## HISTORIC AND DESIGN REVIEW COMMISSION

**HDRC CASE NO:** 2018-104  
**ADDRESS:** 255 BRAHAN BLVD  
**LEGAL DESCRIPTION:** NCB 3856 (255 BRAHAN {AMENDING}), BLOCK 2 LOT 26 & 27  
**ZONING:** RM-4, NCD-9  
**CITY COUNCIL DIST.:** 2  
**APPLICANT:** Ricardo Turrubiates  
**OWNER:** PEP Capital LP  
**TYPE OF WORK:** Conceptual approval of a master site plan for the construction of four, single family residential structures  
**APPLICATION RECEIVED:** March 02, 2018  
**60-DAY REVIEW:** May 01, 2018  
**REQUEST:**

**Historic and Design Review Commission  
Design Review Committee  
Report & Recommendation**

## PROPOSED SITE PLAN

Revised Site Plan For  
Conceptual Approval April. 4, 2018

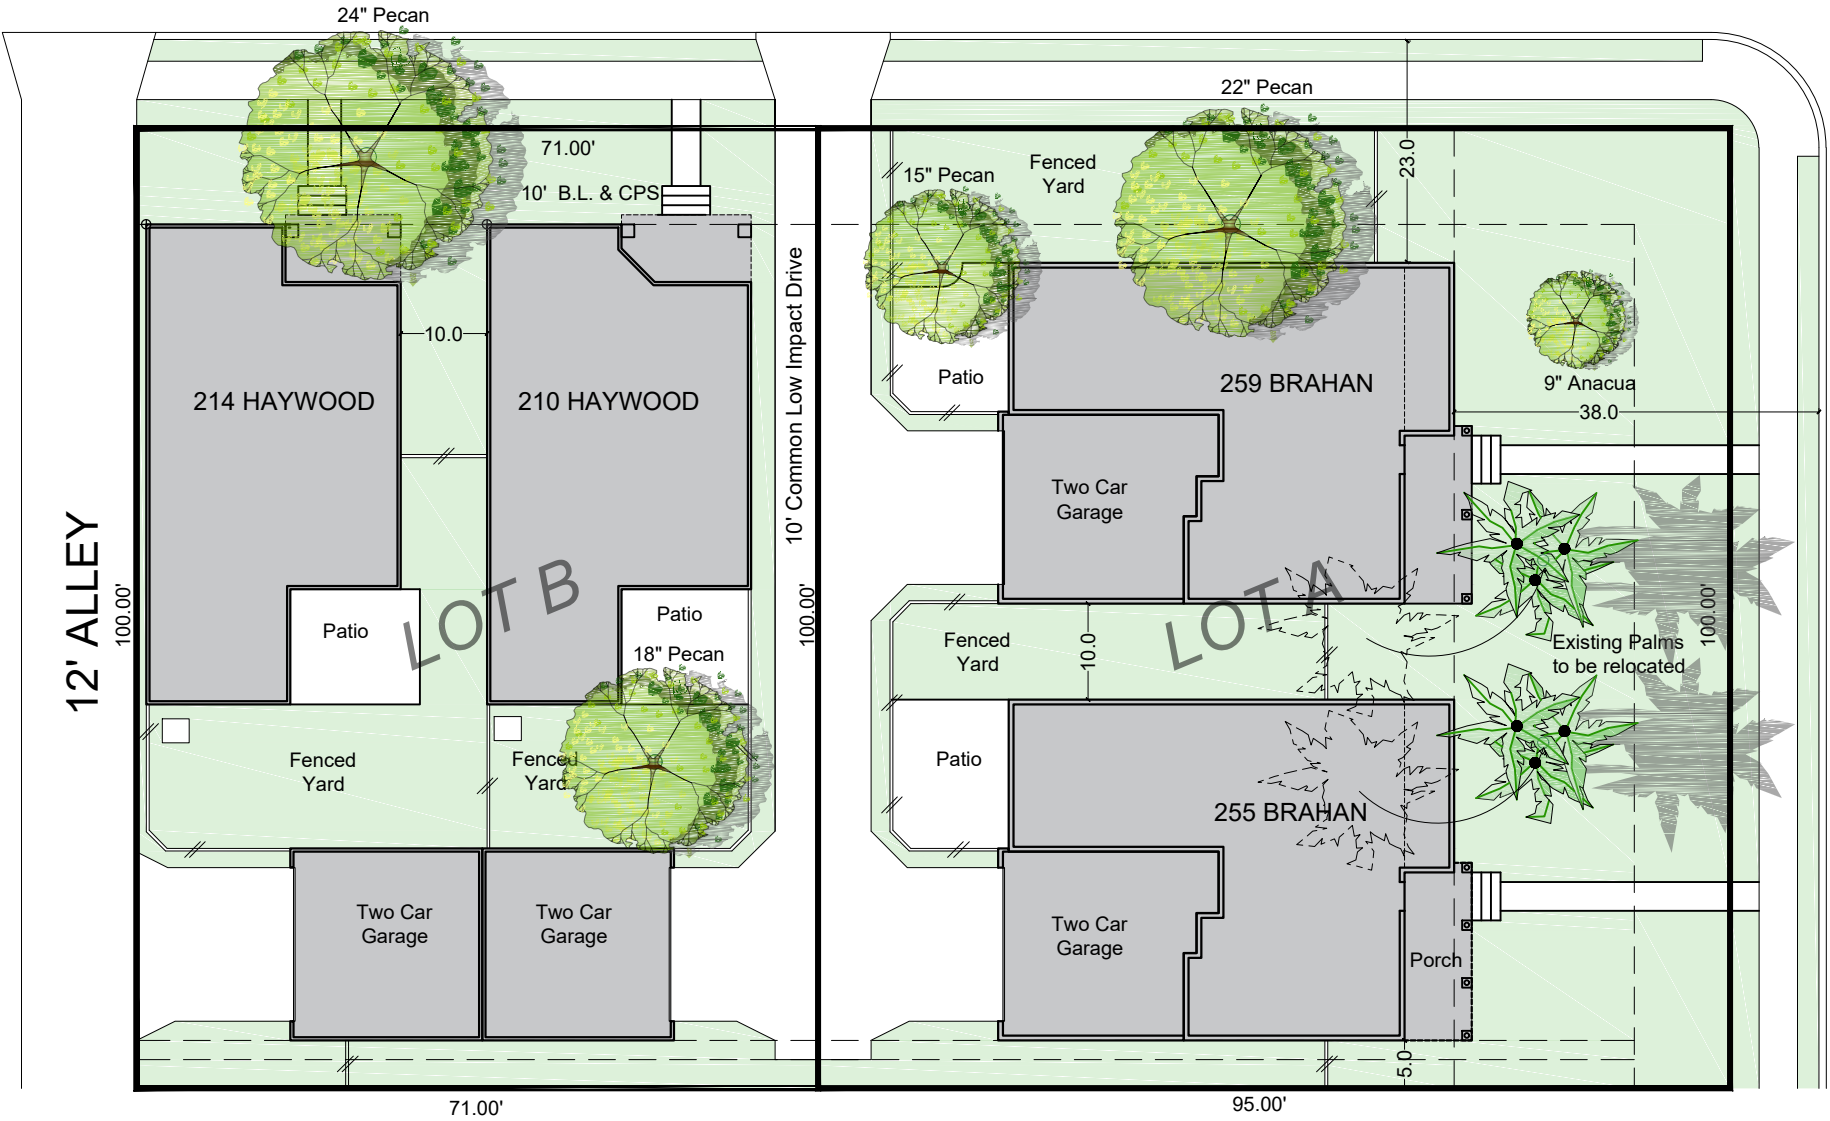
- d. **SITE PLAN** – The applicant has provided a site plan that notes the construction of four, two story residential structures. Two structures are proposed to be constructed on each lot. The applicant has noted one curb cut on Haywood Avenue as well as rear alley access to the site to provide vehicular access to the three remaining units.

- e. **SETBACKS (BRAHAN)** – Per the Guidelines for New Construction 1.A.i., the front facades of new construction should be aligned with the front facades of adjacent buildings where a consistent setback has been established along the street frontage. Where a variety of setbacks exist, the median setback of buildings should be used. The surrounding structures, many of which are not historic, feature varying setbacks. The applicant has provided a diagram noting the existing setbacks on this block of Brahan which include setbacks of 44', 57' 34' and 43'. East of Haywood Avenue, houses feature setbacks of 46', 32', 42', 39' and 60'. The applicant has proposed setbacks on Brahan Blvd of approximately 38'. Staff finds that a setbacks that is more consistent with the contributing properties on the block (45') would be more appropriate. An increased setback on Brahan would likely reduce the feasibility of constructing four houses on the site.

- f. **SETBACKS (HAYWOOD)** – Per the Guidelines for New Construction 1.A.i., the front facades of new construction should be aligned with the front facades of adjacent buildings where a consistent setback has been established along the street frontage. Where a variety of setbacks exist, the median setback of buildings should be used. The surrounding structures, many of which are not historic, feature varying setbacks. The applicant has noted existing setbacks on Haywood Avenue of 20' and 29' from the street within the neighborhood. The applicant has proposed setbacks of 20' for the proposed new construction. Staff finds that a minimum setback of 20 feet from the street should be maintained along Haywood.

- g. **BUILDING SPACING** – The applicant has proposed building spacing of 10' – 0" between the proposed structures. Building on this block of Brahan feature predominately open yards with building spacing ranging from 10 to 59 feet historically. A minimum building spacing of 25 feet would be more appropriate. Additionally, staff finds that detached garages are more typical of the historic development pattern in the area and should be implemented

- h. **ORIENTATION** – As proposed, two homes are oriented to face Brahan, and another two homes are oriented to face Haywood. While two historic homes in the vicinity feature accessories that are accessed from Haywood, there is not an established pattern for primary residences facing Haywood.

- i. **SITE DESIGN** – The applicant has provided a conceptual site plan noting the locations of driveways, walkways, existing trees, proposed trees, fencing and open space. The applicant is proposing to avoid the addition of curb cuts on Brahan by providing vehicular access from Haywood and the rear alley. This is consistent with the historic development pattern of the block. Generally the proposed locations and design of site elements are appropriate.

- k. **DRIVEWAYS** – The applicant has noted the installation of a driveway with access to the lot from Haywood and a driveway with access to the lot from the rear alley. The Guidelines for Site Elements 5.B. notes that new driveways should not exceed ten (10) feet in width. Additionally, the Guidelines note that new curbcuts and driveways should not be added where they did not previously exist. While not historically found in the district, staff finds the proposed curbcut and driveway on Haywood appropriate; however, the initial approach should to exceed ten (10) feet in width.

AMG: QUESTIONS REGARDING DRIVEWAY + APRON WIDTHS, QUESTIONS  
REGARDING SETBACKS - UPDATED SETBACKS ARE NOW 36'-6".

MD: FOOTPRINTS FRONTING BRAHAN ARE OKAY. STRUCTURES FACING HAYWOOD ARE NOT APPROPRIATE.

DL: THERE ARE NO STRUCTURES EXISTING FACING HAYWOOD - THIS IS NOT THE NORMAL PATTERN,

Staff does not recommend conceptual approval of the proposed site plan at this time. Staff recommends that the proposed site plan be revised to address the following:

- i. That the applicant dramatically increase the proposed setbacks from Brahan to be a minimum of 45 feet based on finding e.
- ii. A minimum setback of 20 feet from Haywood should be maintained in the proposal based on finding f.
- iii. A minimum spacing of 25 feet between the proposed homes should be maintained based on finding g.
- iv. With the recommended increased setbacks and building spacing, at least one of the homes facing Haywood should be eliminated from the proposal based on findings e through g. It would be most appropriate to eliminate both homes facing Haywood based on finding h.
- v. That detached parking be incorporated instead of rear-loading attached garages based on finding g.
- vi. That the applicant develop sidewalks, walkways, and driveways to match those found historically in the district based on findings j and k.
